From: Halcomb John W
Sent: Thursday, January 12, 2006 2:46 PM
To: Axelson, William L
Subject: CORRECTIONS AS DISCUSSED

UNIT 1 and UNIT 2 STORM DRAIN OVERVIEW

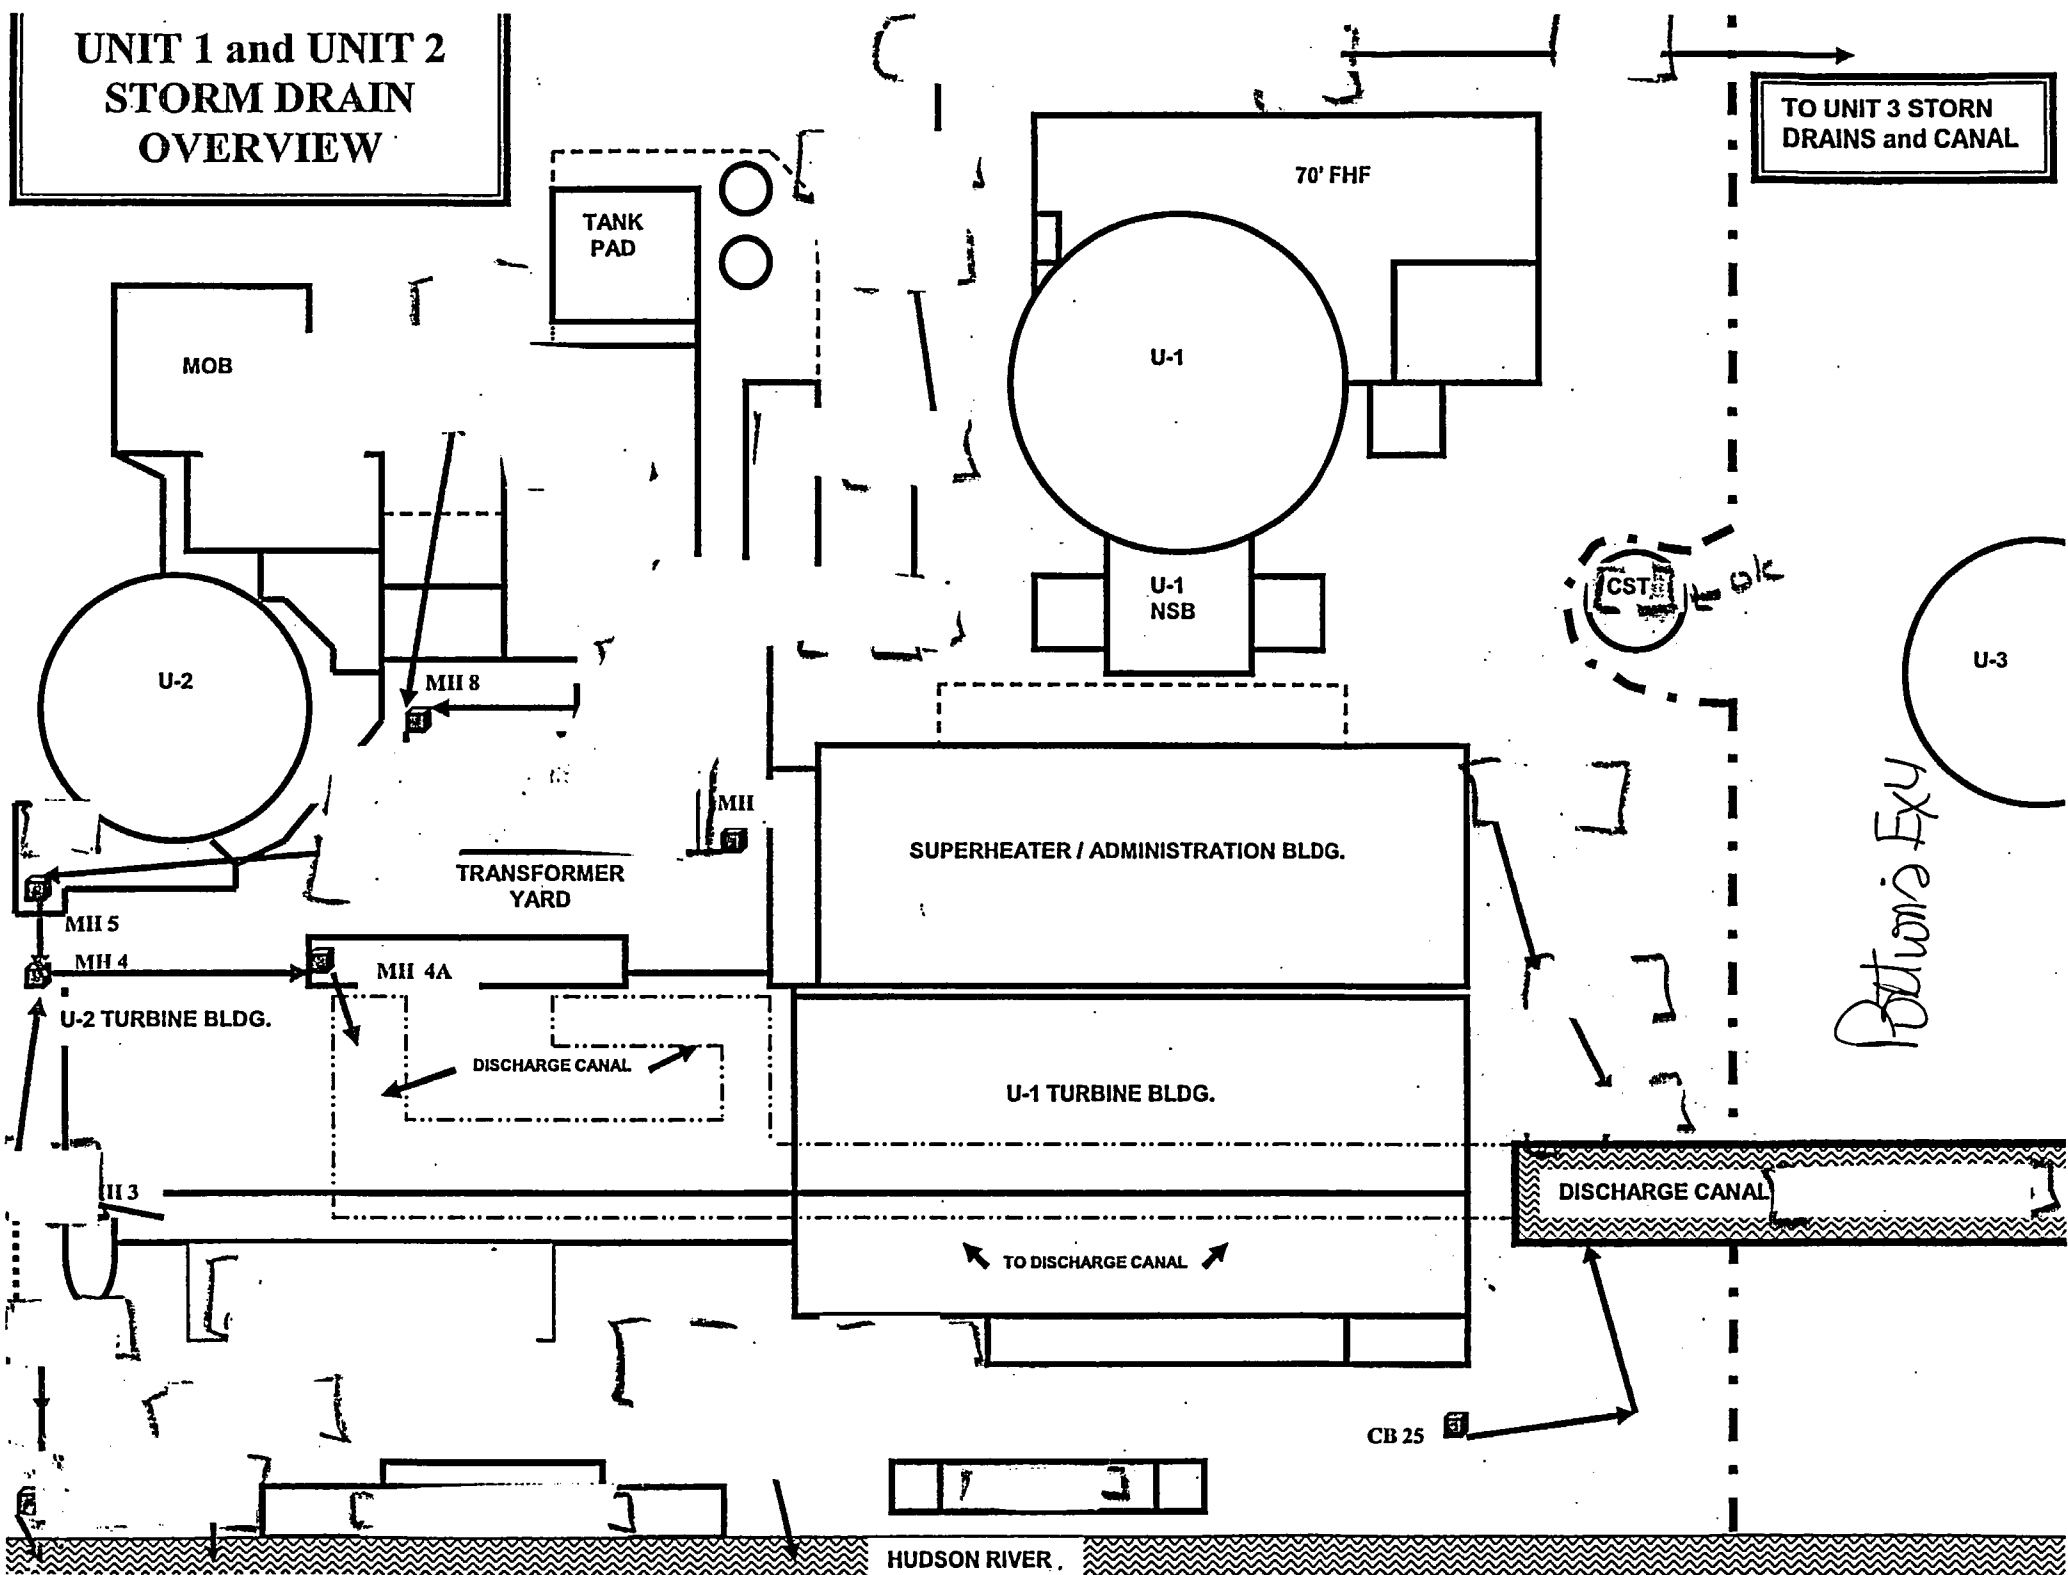
Here is the most up to date unit 2 storm drain schematic that has been walk down and checked against our current drawings-we are currently working on another drawing to show unit 3 storm drains from CB-24-these drains all go to the unit 3 canal.
